Final Drainage Report

Lot 1 The Rock Commerce Center

Subdivision Filing No. 1

July 28, 2023
Project No. 23009.001

STORMCAD NETWORK PREVIEW THE ROCK LOT 1 FILING NO. 1

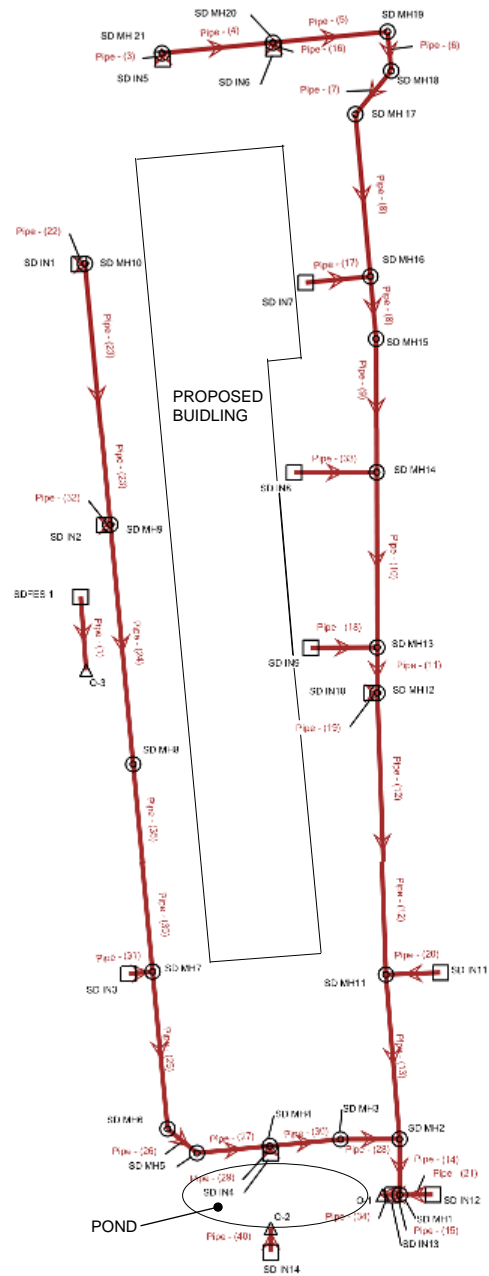
Labels are hard to read for pipes.

Engineering Profile - SD MH2 to SD IN5 - 100 Year Event

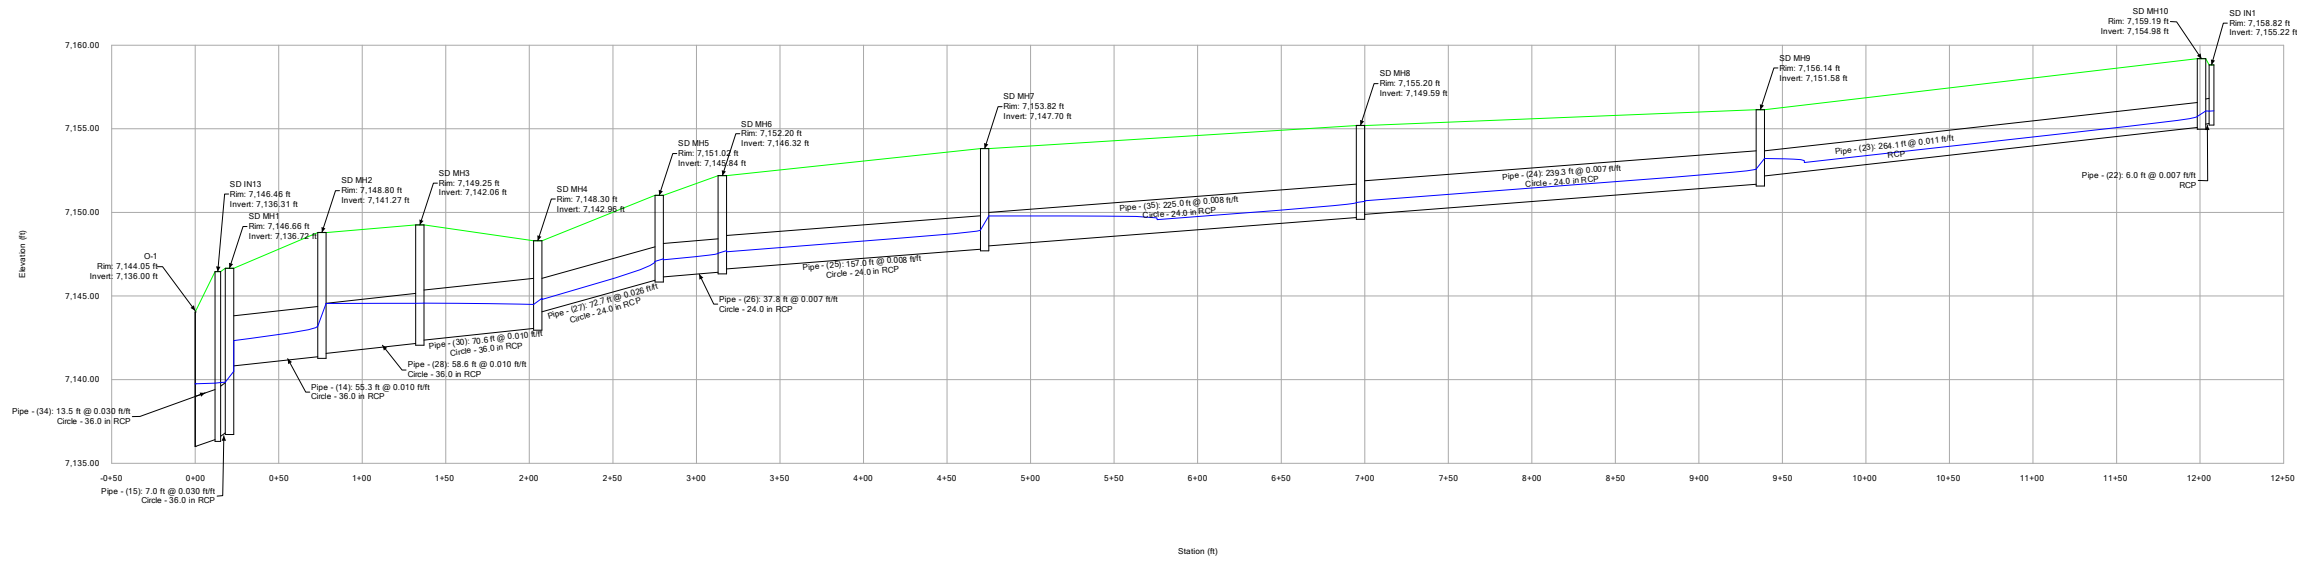
Please provide 10-year event profile

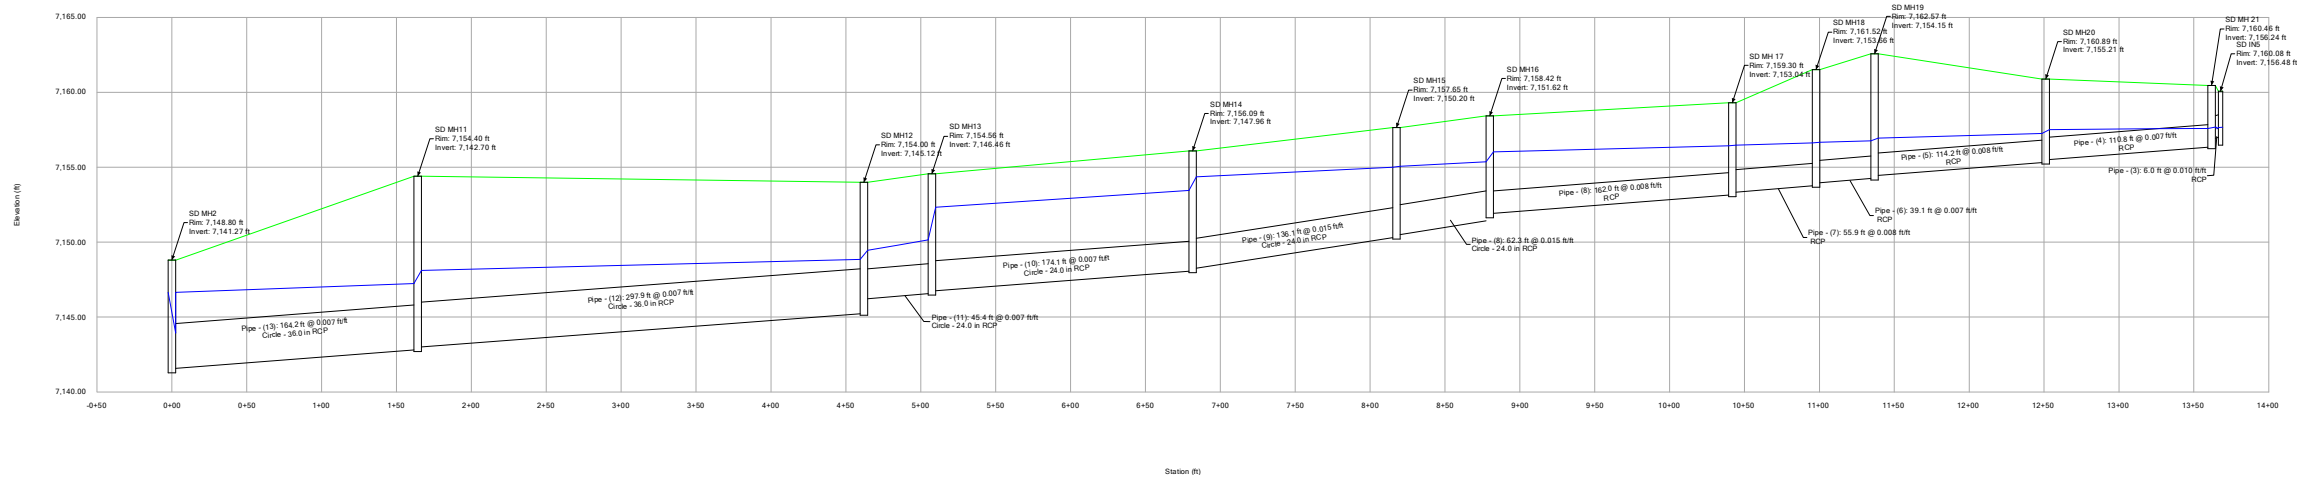
Per ECM Section 3.3.1.D pipes shall be designed to flow full and free of pressure head, except for short runs. Please revise design to eliminate pressure head.

Engineering Profile - SD MH2 to SD IN5 - 10 Year Event

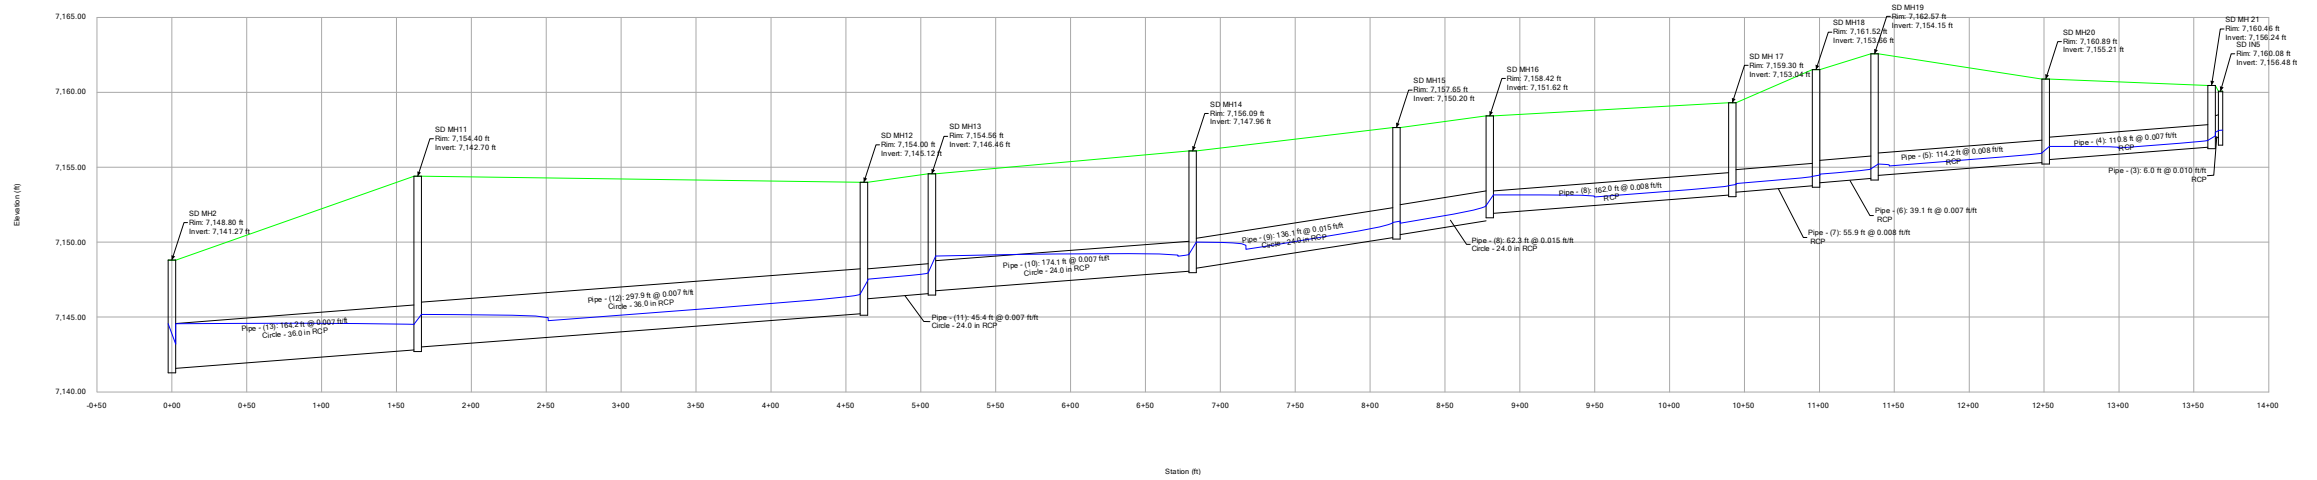
10-year and 100-year profiles were switched.
Please place in correct spots

Profile Report
Engineering Profile - O-2 to SD IN14 - 100 Year Event

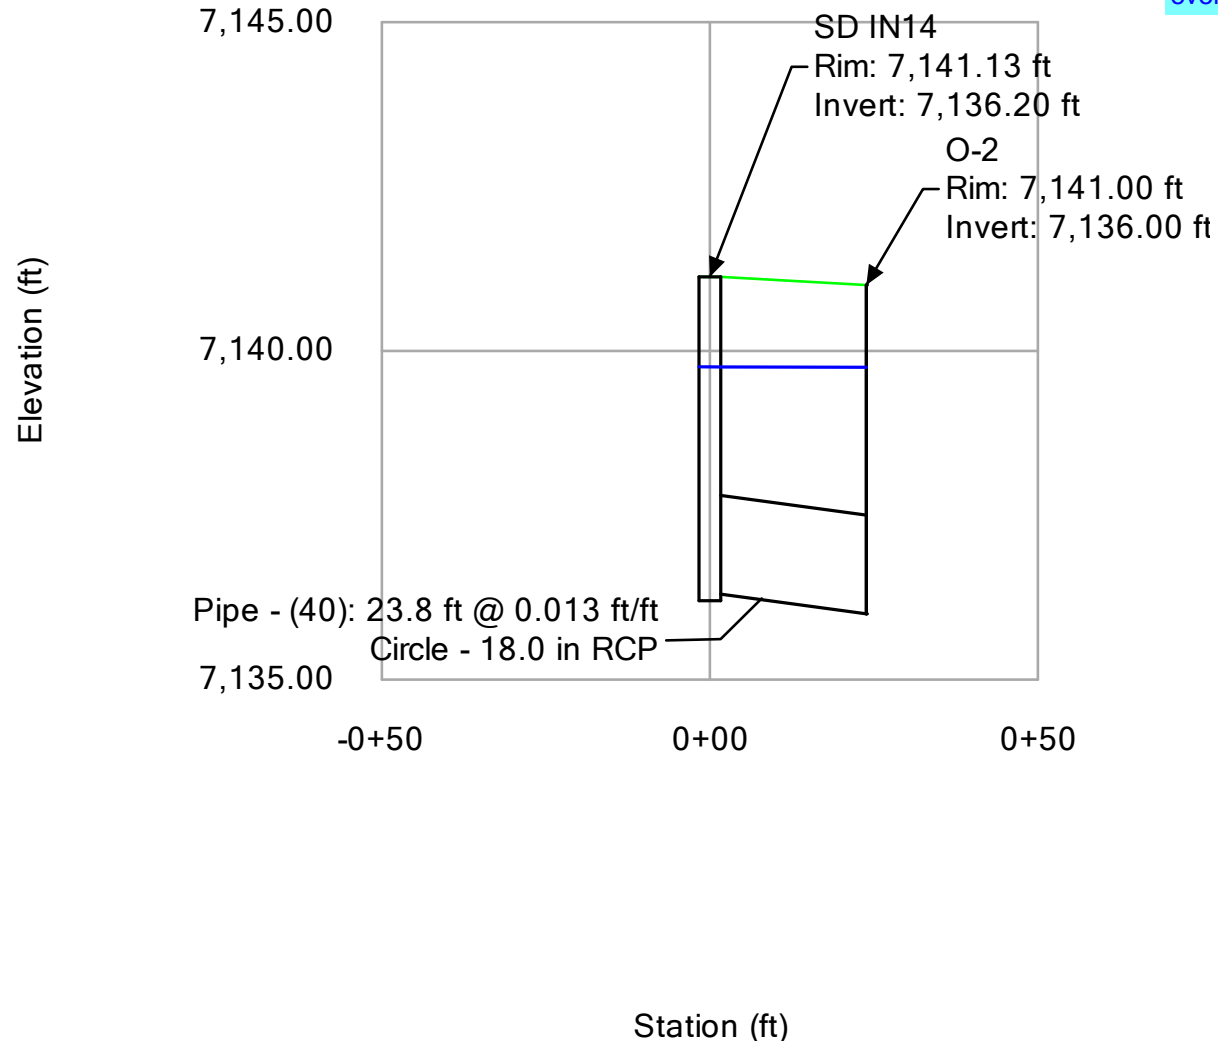
10 and 100-year profiles look the same for this pipe run. Verify each profile event.

Engineering Profile - O-3 to SDFES 1 - 100 Year Event

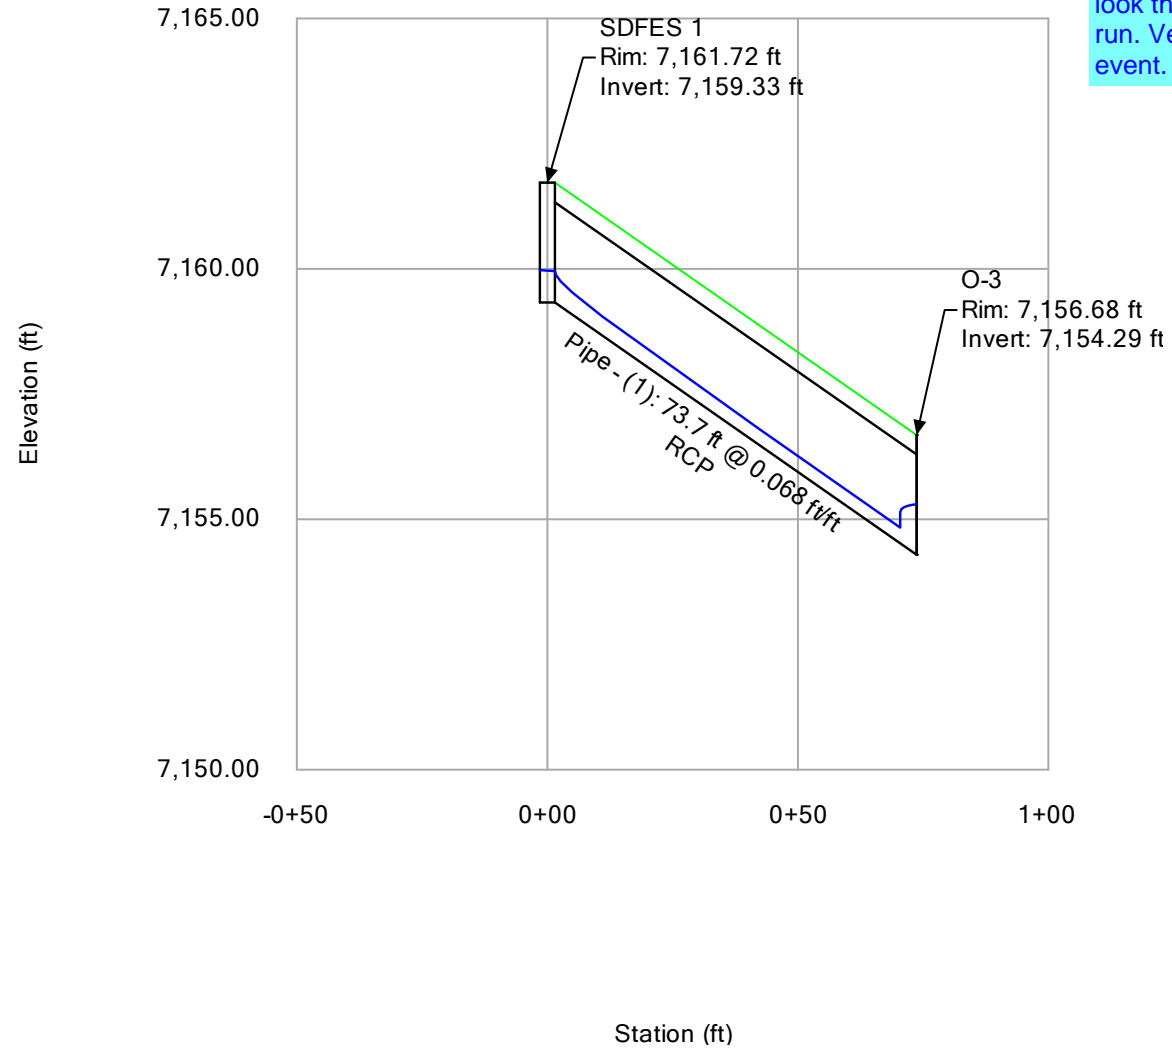
10 and 100-year profiles look the same for this pipe run. Verify each profile event.

SHEET
DNG-1

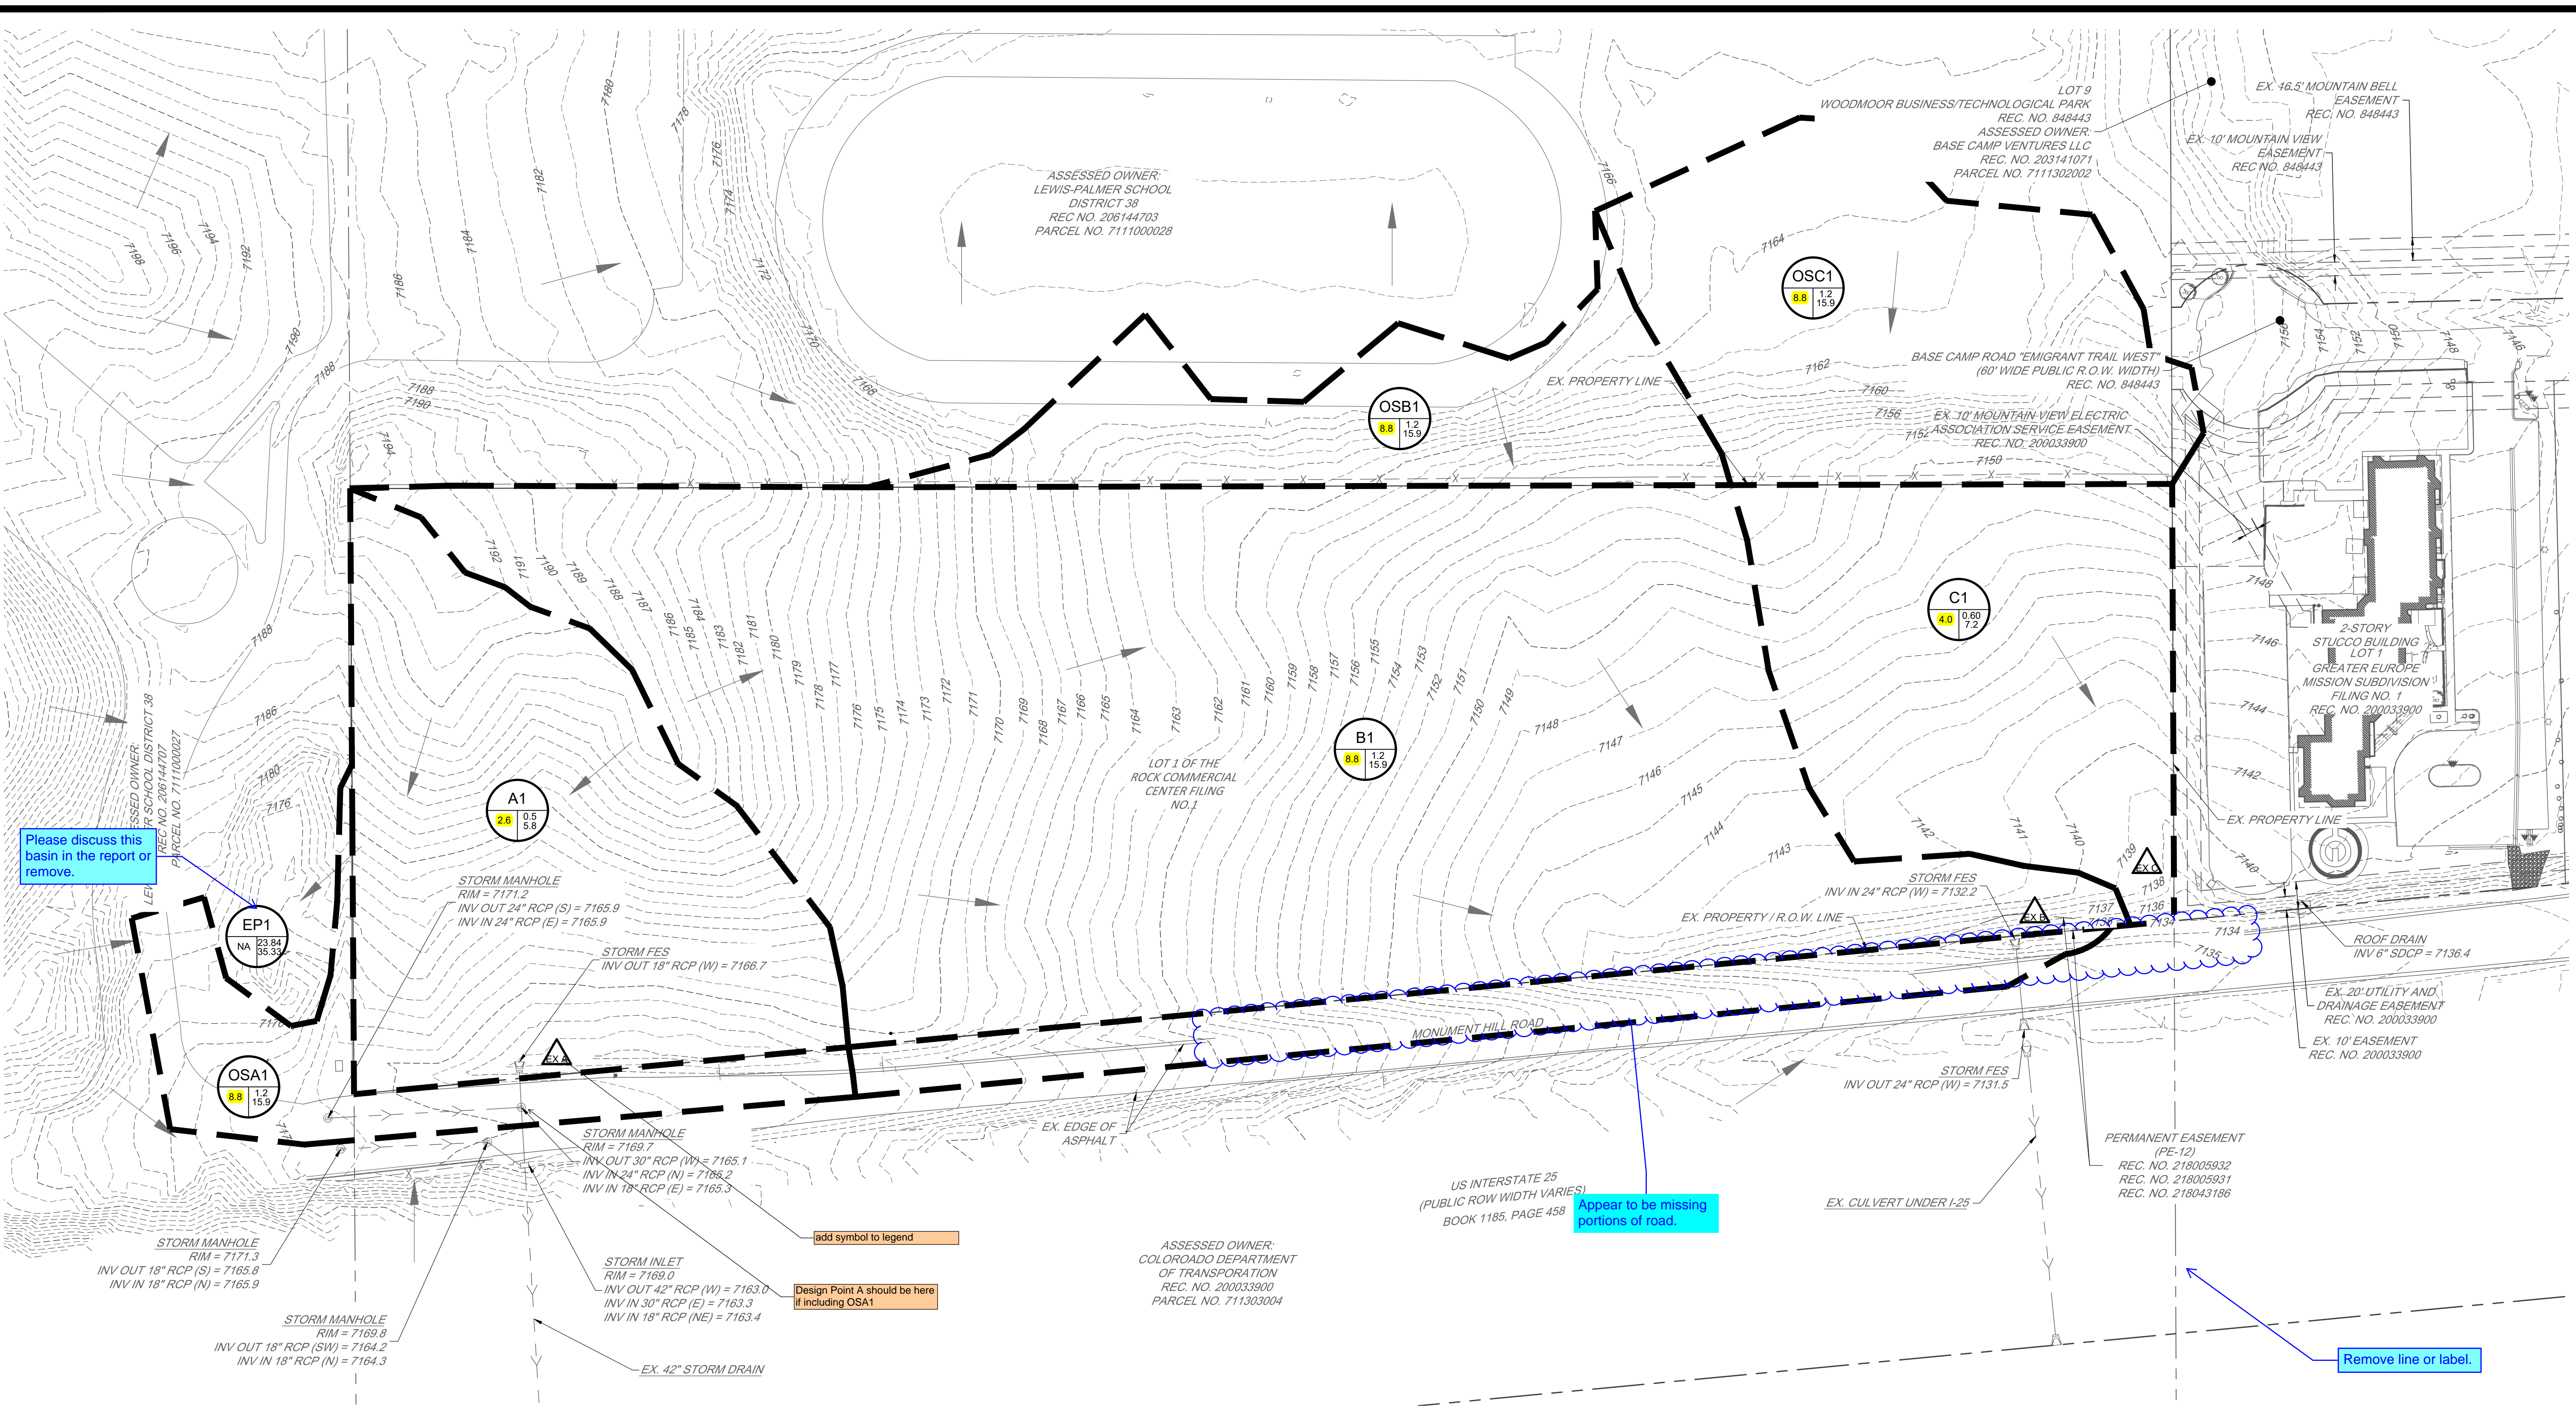
Include design points in the legend.

Flows shown do not match spreadsheet
